**6.3** 218 ESPLANADE WEST, PORT MELBOURNE

**1. PURPOSE**

- 1.1 To consider and determine Planning Permit application P320/2018 for demolition of existing dwelling, shed and associated fences and construction of a two storey dwelling and crossover to the road to the south of the site.

Image: First floor section of wall opposite the secluded private open space of No. 2 Lagoon Place.

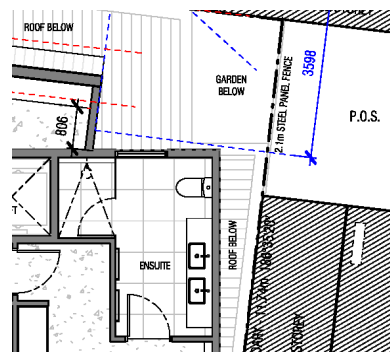
11.4.6 The proposal requires a variation to the rear setback requirement on the eastern boundary. The proposed 7.4 m high wall would have a zero setback increasing to 0.9 m from the eastern boundary. Under this Standard the setback would be 2.49 m. As such, the proposal seeks a variation of 1.59 m.

11.4.7 The majority of the wall would be opposite the dwelling (built to the shared rear boundary). However, part of the wall (the last 0.8m) would be opposite the secluded private open space of No. 2 Lagoon Lane.

11.4.8 The proposed variation to the setback requirement is unlikely to result in an unreasonable loss of amenity given the small section of wall facing the secluded private open space. The section of wall that does not comply is small. Occupiers of the secluded private open space would still have a reasonable level of outlook along the northern boundary of the subject site. Therefore, the proposed variation would not result in a loss of amenity in terms of visual bulk, loss of outlook or create a sense of enclosure. A variation is therefore considered appropriate in this instance.
